RE: 16484 Kennedy Road - Parcel 2

I reviewed the drawings and evaluated the site context. My comments and recommendations are as follows:

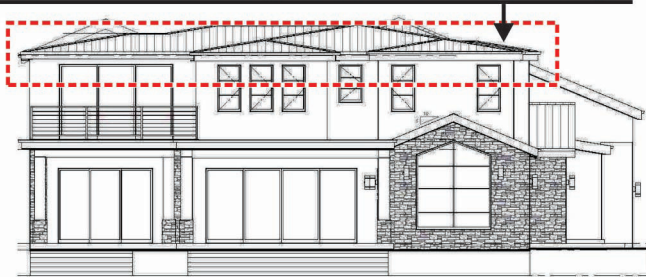
1. The wide difference in roof slopes and heights, including 2:12 and 5:12 slopes, is visually awkward, and do not work well in creating a unified design. It appears as though a traditional style, large home has been scrunched down, unnecessarily except for a one-size-fits-all universal requirement in the Town's *Hillside Standards and Design Guidelines*. And, this variation in roof slopes is not consistent with Residential Design Guideline 3.5.1.

Shallow 2:12 roof slope is not consistent with the remainder of the design and the architectural style

3. Strongly consider increasing the roof slopes to be more consistent with the proposed architectural style, and the slopes proposed on the home's front elevation. To achieve this, floor-to-ceiling heights may need to be reduced to conform with the building height limitations in the Hillside Development Standards and Guidelines

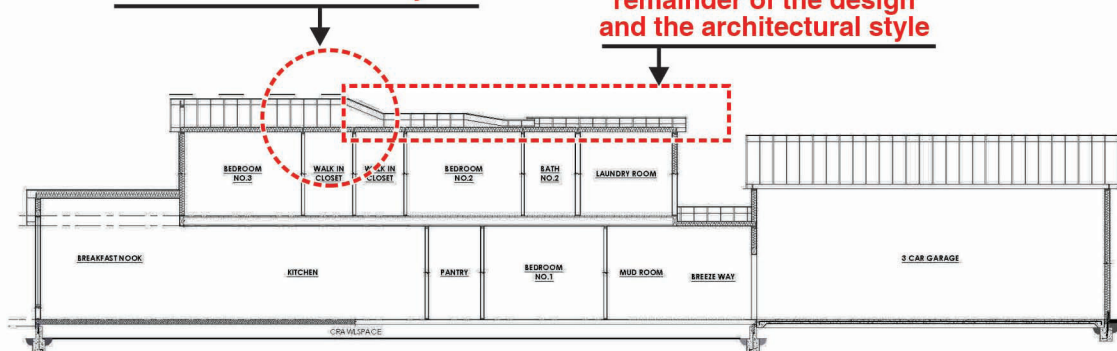
2. The truncated roof ridge and full rear gable on the front of the house are awkward, and not consistent with the architectural style.

Truncated gable roof ridge is awkward and not consistent with the architectural style

Shallow 2:12 roof slope is not consistent with the remainder of the design and the architectural style

1. Terminate the front gable ridges further back from the front facade to reduce the visibility of the truncated form.

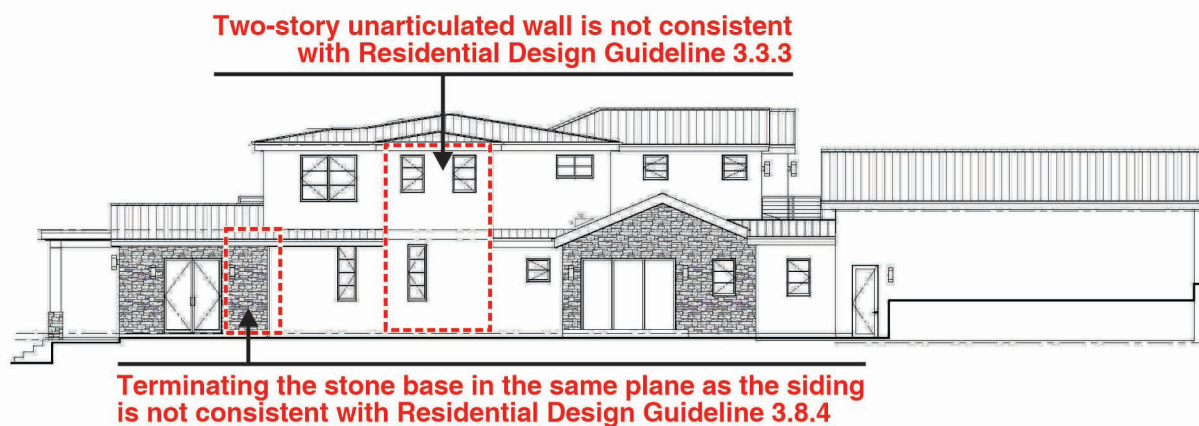
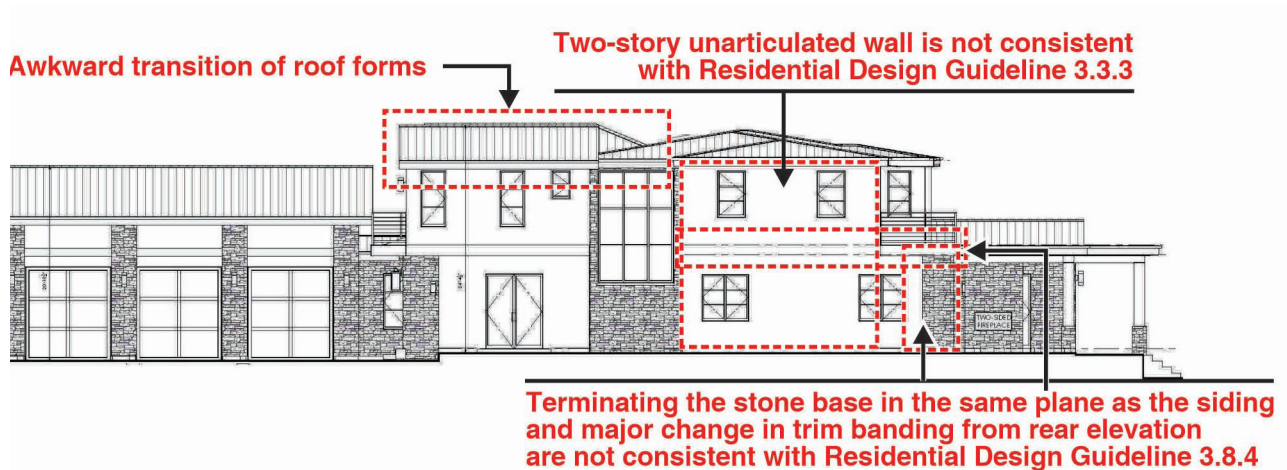
3. There are a number of places where materials are changed in the same plane or at an outside corner which is not consistent with Residential Design Guideline 3.8.4.

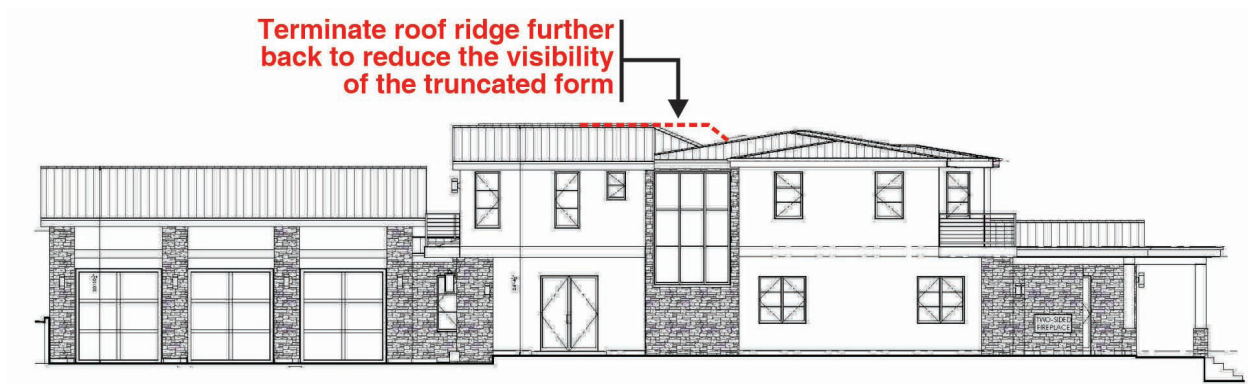
4. The two-story unarticulated wall on the right and left side elevations are not consistent with Residential Design Guideline 3.3.3.

5. There is an inconsistency in the use and color of belly band trims on the rear and side elevations

2. Coordinate the size and color of the belly band trim, and add to all unarticulated two-story walls.
